Access Compliance Report

Public Rights-of-Way

(Curb Ramps)

Intersection ID: 11472	Main Street: FARM_GATE_DR	Cross Street: WILLIAMS_RD	Location: W
ADA ID: 74BFE71B7DC8	Ramp Type: Perp	Initial Pass/Fail: Fail	Overall Compliance: No
Severity Score: 37.5			
Codes/Mitigation Info/Possible Solution		Field Measurements/Component Compliance

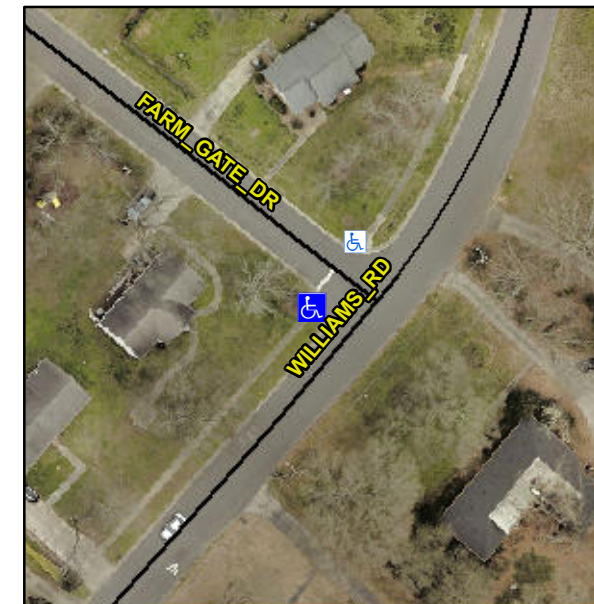
Not Found, R304.2.2, R304.5.3

Compliance	Description	Data	Compliance	Description	Data
N/A	Ramp Length (in)	76.5	No	Ramp Slope (%)	8.8
Yes	Ramp Width (in)	48.0	No	Ramp XSlope (%)	8.7
N/A	Flare Type LT	N/A	N/A	Flare Type RT	N/A
N/A	Flare Slope LT (%)	N/A	N/A	Flare Slope RT (%)	N/A
N/A	Flare Traversable LT?	N/A	N/A	Flare Traversable RT?	N/A
N/A	Landing Length (in)	N/A	N/A	DWS Provided?	N/A
N/A	Landing Width (in)	N/A	N/A	DWS Contrast?	N/A
N/A	Landing Slope (%)	N/A	N/A	DWS Length (in)	N/A
N/A	Landing X Slope (%)	N/A	N/A	DWS Full Width?	N/A
N/A	Landing Curb? (Y/N)	N/A	N/A	DWS Offset (in)	N/A
N/A	Shared Landing?	N/A			
N/A	Gutter Ponding?	N/A	N/A	Gutter Slope (%)	N/A
N/A	Gutter Lip Ht (in)	1.0	N/A	Gutter X Slope (%)	N/A
N/A	Painted X Walk1?	No	N/A	Painted X Walk2?	N/A
	X Walk 1 Direction	To NE		X Walk 2 Direction	N/A
N/A	X Walk 1 Width (in)	N/A	N/A	X Walk 2 Width (in)	N/A
	X Walk 1 Slope (%)	1.6		X Walk 2 Slope (%)	N/A
	X Walk 1 X Slope (%)	3.2		X Walk 2 X Slope (%)	N/A

Remove & Replace Entire Ramp.
